UI Bulletin #182

Subject: Vehicle Speed Signal
Models Years Affected: 2021
Models Affected: Silverado HD 4500/5500/6500 Models
Origination Date: October 6, 2021
Revision Date: N/A

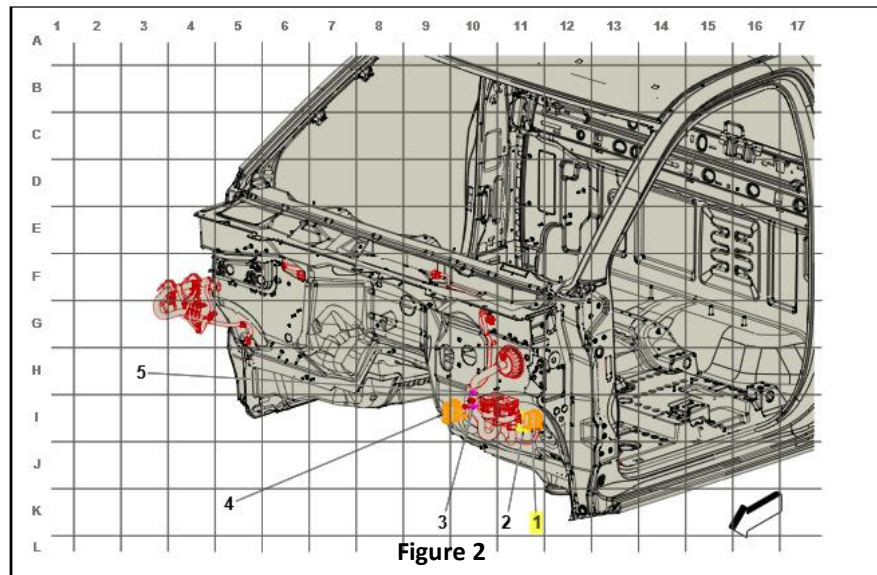
If the added equipment requires a V+ pulse to operate you can use the signal as it is provided, however you will need to add a current limited V+ circuit which is pulled low by the EBCM and release back to the V+ state. The release of the V+ signal appears to the added equipment as pulsed + signal. For use of this signal please refer to Figure 1 below for mechanization instructions.

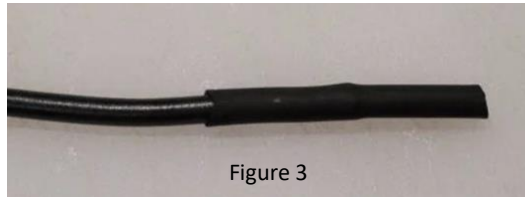
1. Locate and disconnect the 40 way X138 connector (item 1) as shown below in figure 2

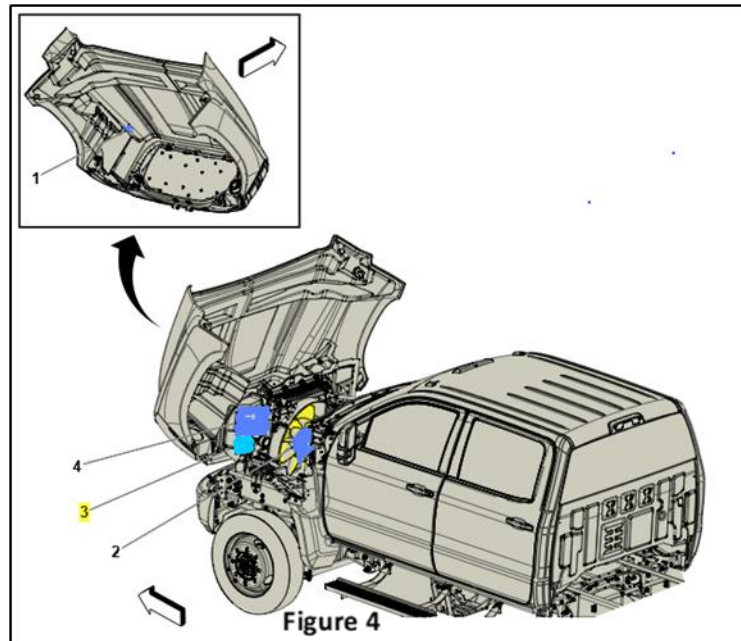
2. Locate the red wire in cavity 40 of the chassis side of the X138 connector, measuring approximately 6-8 inches back from the X138 connector (removing harness wrapping as needed) cut the red wire, leaving a 6-8 inch pigtail coming the connector. Seal the chassis harness blunt cut end using shrink wrap extended past the cut end, then by heating and pinching off the shrink wrap extension (as shown below in Figure 3)

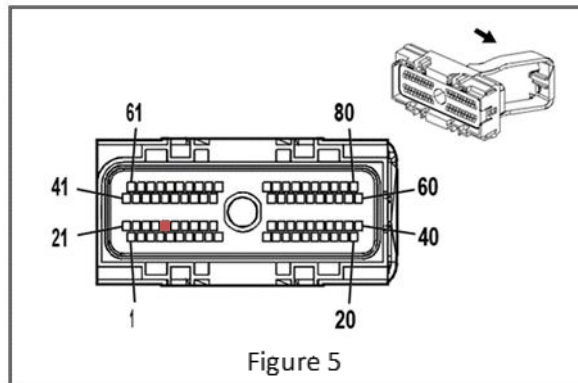
3. Obtain approximately 10 feet of $.75\text{mm}^2$ sized wire (preferably a green (w/gray if possible)) to the red pigtail from cavity 40 of the chassis side of the X138 connector.
4. Safely route and secure the wire to the TCM/connector located as shown in figure 4

- Remove the connector from the TCM...Locate the unused/molded over cavity 25.

- The molded over cavity can be easily opened using a small sharp wire pick.
- Once the over-mold material has been removed, install terminated wire lead P/N13578813 (available from any GM dealer parts department).

- Cut to length the added green wire to match the location of the terminated lead
- Slide a section of shrink tube over the green wire and back away from the soon to be soldered wire ends.

- Using rosin core solder – solder the new green wire to the terminated wire lead add to cavity 25 of the TCM connector. Seal the soldered joint with the heat shrink tube.

- Returning now the blunt cut red wire at the X138... add a section of heat shrink tube over the added green wire, strip and solder the red wire pigtail to the added green wire.

- Confirm again that the added green wire is secured and safely away from any heat sources and/or moving components
- Reconnect the connectors and test upfit device for proper operation.

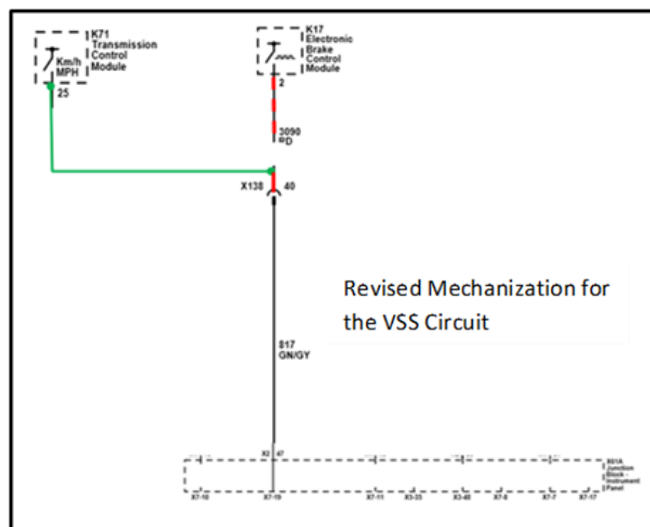
- When complete the revised mechanization should reflect the schematic in Figure 6
